APPENDIX D

RESPONSES TO COMMENTS ON THE DEIS

The Draft Environmental Impact Statement (DEIS) for the proposed Idaho Cobalt Project (ICP) was noticed in the Federal Register on February 23, 2007. The public comment period ran from February 23 through May 24, 2007. Two public meetings were held to take comments on the DEIS; in Salmon on May 14, 2007 and Challis on May 15, 2007. A total of 173 comments and comment letters were received by the agencies. Each comment or comment letter was assigned a number to allow tracking of the input from each commenter. A commenter is anyone who submitted written comments in a personal letter, a form letter, a postcard, or a petition, and/or presented testimony at a public hearing on the DEIS. Table D-1 contains a list of comments received on the ICP DEIS and an identification number assigned to each comment or comment letter. The comment ID number makes it possible to track each comment and match it with a response.

Figure A. Range of predicted copper from DEIS and Golder.

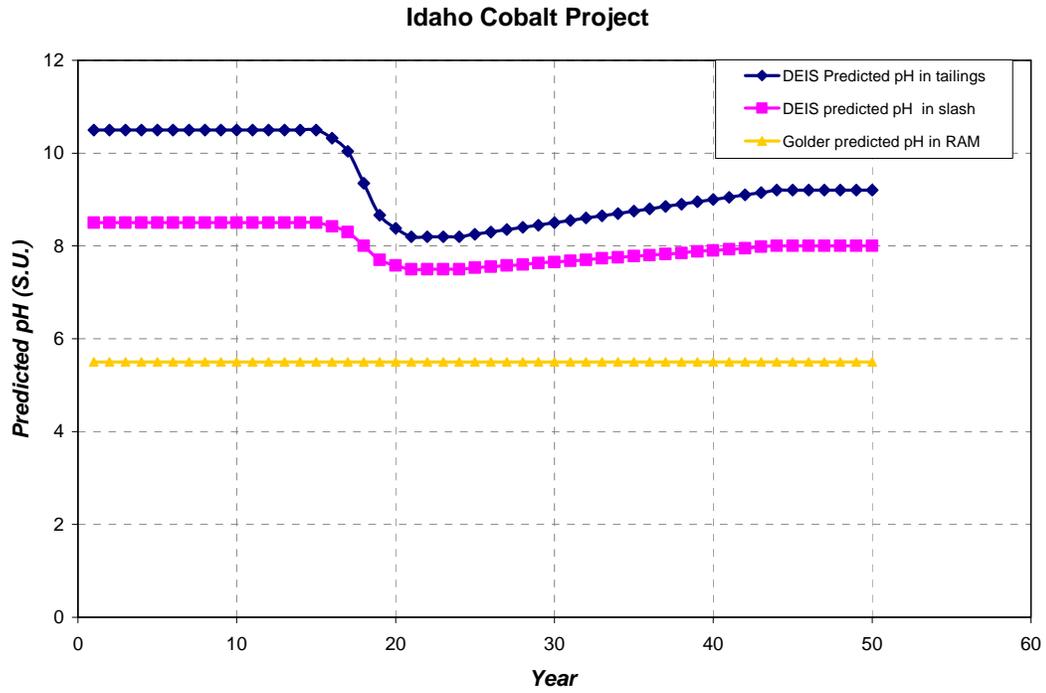
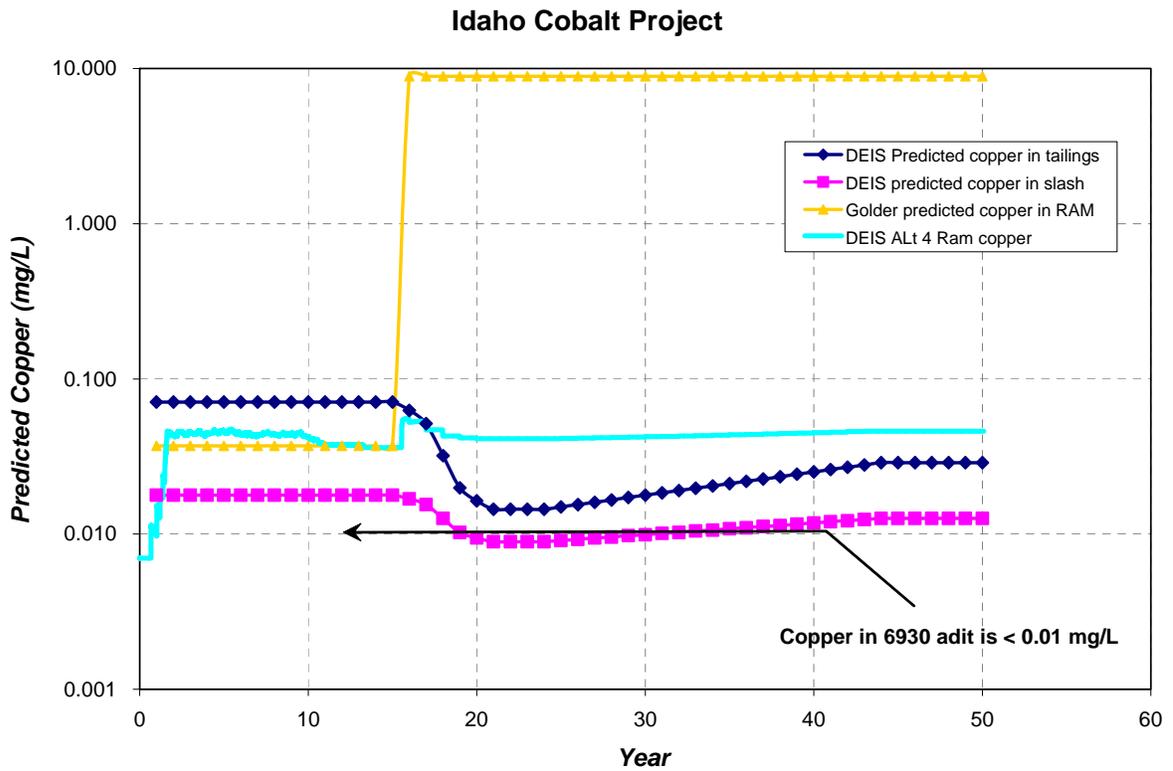
Comment: Before evaluating the various alternatives, it is important to understand the water quality impacts that will occur if there is no mitigation or if the proposed mitigation is not successful at the ICP. The DSM used by the USFS was used to evaluate the impact of the ICP on Big Deer Creek and Panther Creek assuming the mitigation measures were ineffective. All the input values were unchanged except the groundwater capture efficiency was set to 0 percent and the pH in the Ram Slash and Backfill was set to 5.5, which is representative of moderately acidic conditions. A pH of 5.5 is less acidic than the pH 4.5 drainage that was observed within the 6930 portal at the Blackbird Mine. A pH of 5.5 or lower could be reached within the ICP mines if the proposed mitigation (amendments of the backfill) is unsuccessful. (113)

Response: We agree with the Golder Report's prediction that copper would reach the levels projected in their analysis **if the assumptions are correct**. However, we strongly disagree with the way that they have characterized their assumptions for three reasons. First, Golder implies that failure of **either** mitigation measure (e.g. the alkaline amendments or the solution recovery systems) would result in failure to protect water quality. This is untrue. **Both** systems would need to utterly fail for their analysis to be correct. The mitigation measures were designed to be redundant, providing a higher degree of protection than inter-dependent measures would.

The EIS team believes that the pH will be substantially higher than 5.5 in the underground mines. A pH of 5.5 would result in 8.9 mg/L predicted copper in the mine water. We stand by our assertion that pH in cemented tailings will be closer to 11 (Figure A) during mine life and will decrease to the range of 8.0 to 9.0 in the long-term owing to the cement addition to tailings (Figure B). Additionally, we believe that pH in slash will be closer to 8.5 during operation and 7.5 to 8.0 post closure because of alkaline amendment of slash. The resulting predicted copper levels in the underground mine (Figure B) range from 0.014 to 0.029 mg/L in backfilled tailings areas and are around 0.01 mg/L in slash zones. The overall predicted copper in the underground mine (when mine caused loads are added to background concentrations) are around 0.045 mg/L. These copper levels are more than 100 times lower than the levels predicted by Golder and are even higher than copper levels measured in the 6930 adit seep (<0.01 mg/L copper).

The groundwater recovery system is unlikely to fail as suggested by Golder because in Alternative IV, groundwater recovery would be provided by three separate recovery systems, if necessary. If the bedrock groundwater recovery system is unable to collect the requisite loads, then a second alluvial groundwater/surface water recovery system located in the lower Bucktail Creek drainage would be used to collect sufficient loads to off-set any releases from the ICP. If neither of these systems can be proven effective then the mines could be maintained in a dewatered condition post-mining. Thus, Alternative IV provides an essentially failsafe approach to post-mining groundwater containment. Under the proposed Alternative IV, the ICP essentially becomes a partner with BMSG in cleaning up Big Deer and Panther Creek, rather than a protagonist as suggested in the Golder analysis.

Additionally, Golder erred when they performed this analysis using the ICP DSM. The ICP DSM was conducted as a stochastic analysis, meaning that a series of 30 individual model runs were performed to represent the range of conditions that may occur post-closure. Taken as a group, the model results depict the range (and probability) of potential impacts to receiving waters. Golder used a single iteration (realization 12) of the model out of this set of 30 model runs and used the single iteration as the basis for their analysis. Golder then mistakenly purports that the results from this sole run represent the expected water quality that would result if their assumptions were correct. In reality, this run represents one small portion of the range and distribution of potential outcomes if their assumptions prevail, and the results therefore can not be construed to be the expected case result even if their assumptions are correct.

Figure A. Range of predicted copper from DEIS and Golder.

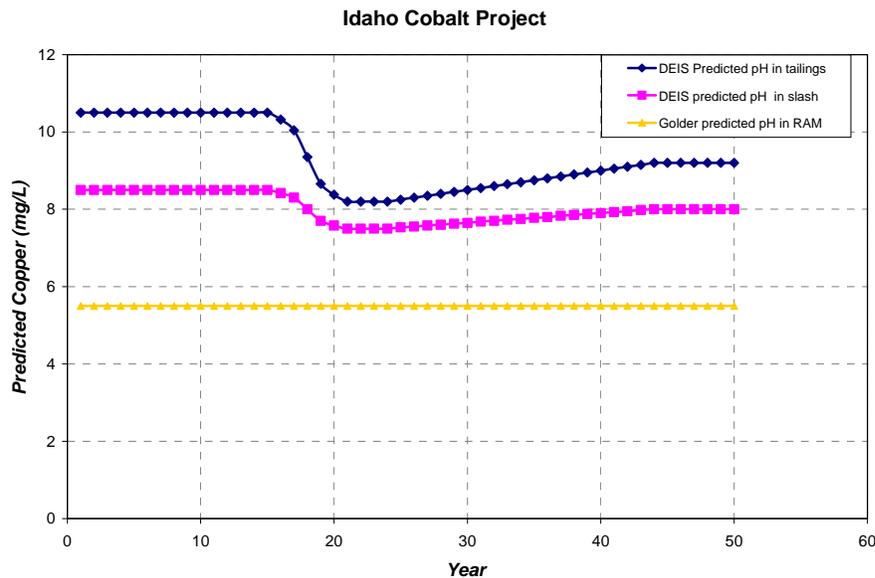
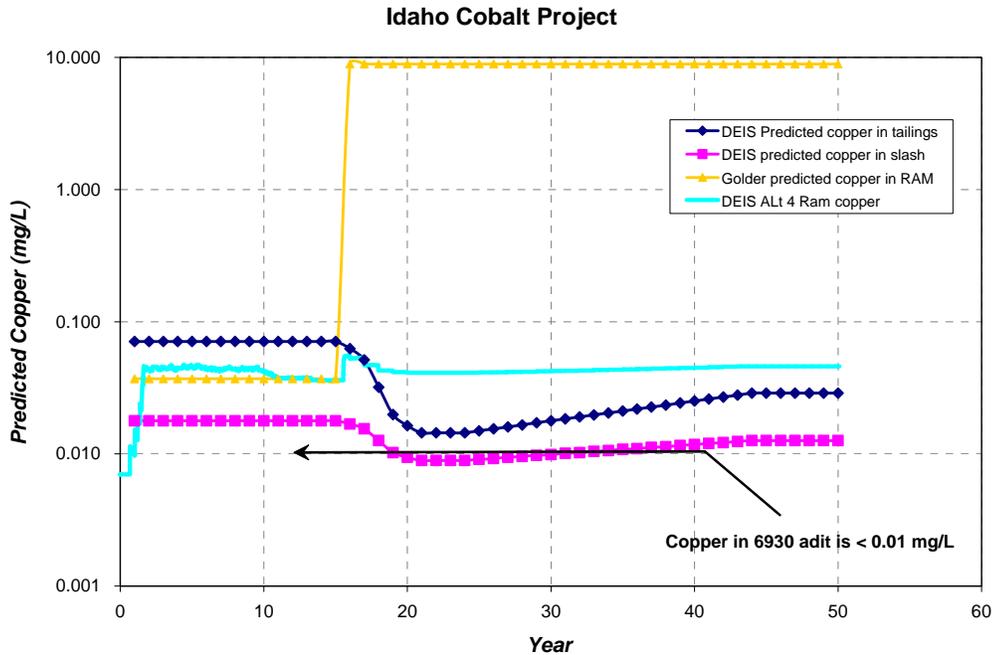
Comment: Absent effective mitigation, copper concentrations in Big Deer Creek would increase to over 50 ppb and concentration of copper in Panther Creek would increase to more than 8 ppb. (113)

Response: If the pH in the underground mines were to decline to 5.5 as assumed by the Golder technical report, and if there was no groundwater recovery employed, and if all metals were transported through the groundwater, alluvium and stream channel systems (as is conservatively assumed by the ICP dynamic systems model developed for the DEIS), we agree that downstream copper levels would increase by the amount described in the Golder report. However, the Agencies disagree with each of the assumptions made by Golder. Namely, the Agencies believe the pH will be substantially higher than 5.5, which would result in 8.9 mg/L predicted copper in the mine water. The Agencies believe that pH in cemented tailings will be closer to 11 (Figure A) during mine life and will decrease to the range of 8.0 to 9.0 in the long-term owing to the cement addition to tailings (Figure A). Additionally, the Agencies believe that pH in slash will be closer to 8.5 during operation and 7.5 to 8.0 post closure because of alkaline amendment of slash waste rock. The resulting predicted copper levels in the underground mine (Figure B) range from 0.014 to 0.029 mg/26L in backfilled tailings areas and are around 0.01 mg/L in slash zones. The overall predicted copper in the underground mine (when mine caused loads are added to background concentrations) are around 0.045 mg/L. These copper levels are more than 100 times lower than the levels predicted by Golder but are even higher than copper levels measured in the 6930 adit seep (<0.01 mg/L copper).

The assumption made by Golder that no groundwater recovery will occur is entirely unreasonable and inconsistent with the requirements of the Plan of Operations as described in the EIS. The Agencies believe that most or all metal loads in groundwater can be intercepted and treated, if needed, and that even if some loads escaped the containment system, they would be unlikely to travel to the receiving water as was assumed in the model. Therefore, the EIS team adheres to the predictions about predicted copper levels in receiving waters described and documented in the DEIS.

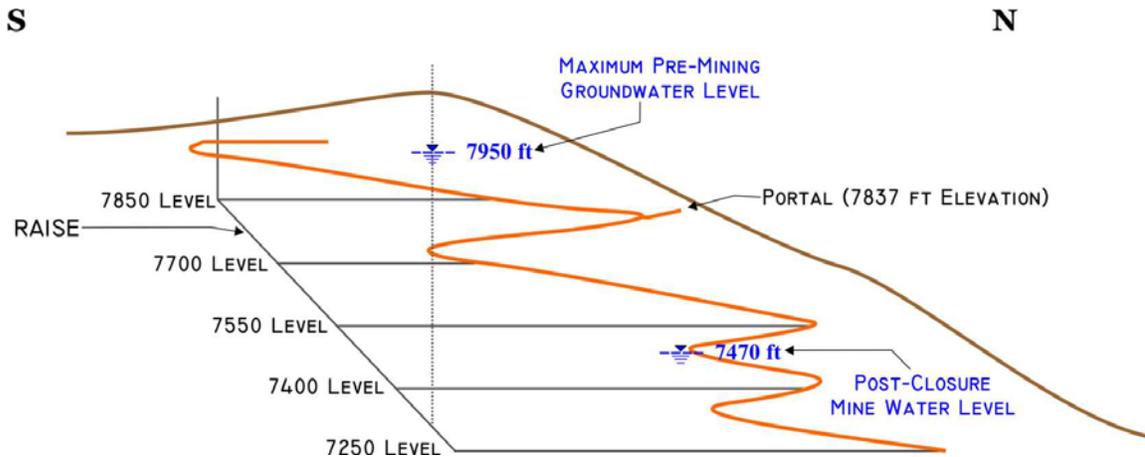
Comment: There is no evaluation in the DEIS on the potential for groundwater to migrate into the Meadow Creek drainage. (155)

Response: The potential for southward groundwater flow from the Sunshine Mine into the Meadow Creek drainage was evaluated by the EIS team and found to not be significant. This is based on the fact that only a small portion of the upper access decline tunnel would be located south of the topographic divide, and the post-mining reflooded portion of the Sunshine workings would all be located north of the topographic divide. As shown in the figure below, the Sunshine workings are predicted to refill with groundwater to an approximate elevation of 7470 feet amsl after mine closure. Based on this prediction, all of the flooded workings would be located north of the topographic divide, thus minimizing the potential for southward migration of mine water into Meadow Creek drainage. (155)

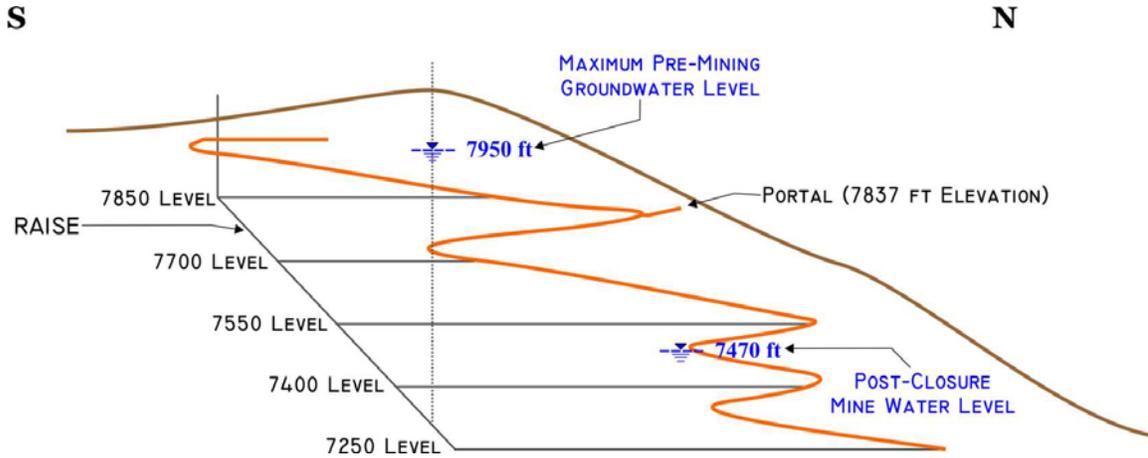
The comment further states that the assumption that groundwater flow generally follows the topographic gradient is only valid if the groundwater system behaves as an isotropic porous media aquifer. This is only partially correct. In reality, the bedrock system need only have a sufficient fracture density and interconnectivity to act as an equivalent porous media aquifer for flow to generally follow topography. As stated in responses to multiple comments (see Comment Response WTR 301-1 and WTR 310), additional safeguards have been incorporated as a result of the EIS analysis to ensure that contaminant migration through groundwater can be adequately controlled should contaminant pathways deviate significantly from those predicted by the equivalent porous

media model. These safeguards include detailed characterization of bedrock groundwater flow through mine inflow and groundwater drawdown monitoring during the mine operational period, and the multiple approaches to groundwater containment incorporated into the plan, including bedrock groundwater pumpback wells downgradient of each mine, and/or backup groundwater capture system in Lower Bucktail drainage, or maintaining the mines in a dewatered condition if necessary. Based on these monitoring requirements and contingencies, the EIS team believes that the quantity of Ram Mine-derived groundwater contaminants potentially reporting to the BMSG, if any, can be adequately quantified and controlled. (155)
